DECLARATION OF IDENTITY AND PERMISSIVE CHANGE.

It is hereby declared; that the GN Netcom developed "BT250" has also been named "BT250v" with the following changes:

BT250 vs. BT250V

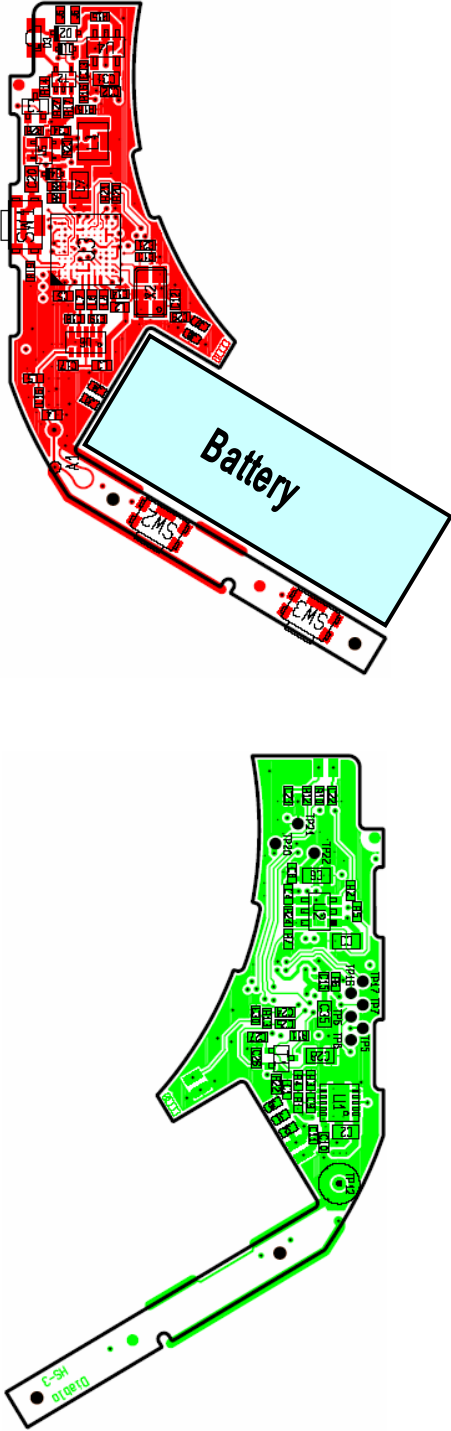
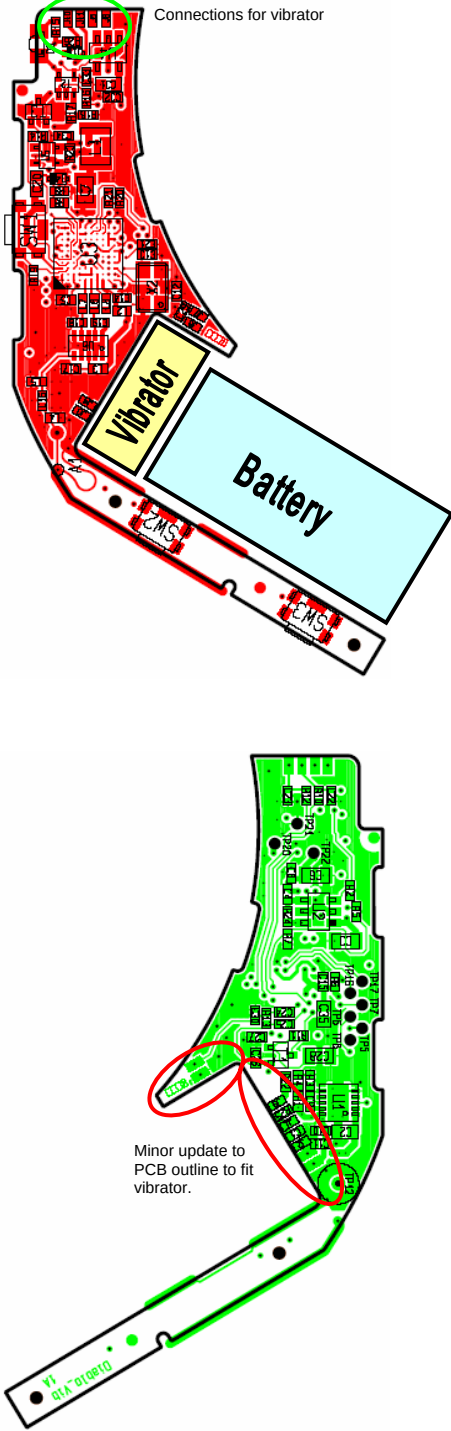
1. Adding of an vibrator
2. Change of battery type to fit with space.
3. Minor changes to PCB to integrate a vibrator.

Electrical and PCB layout comparison between BT250 versus BT250V is given below.
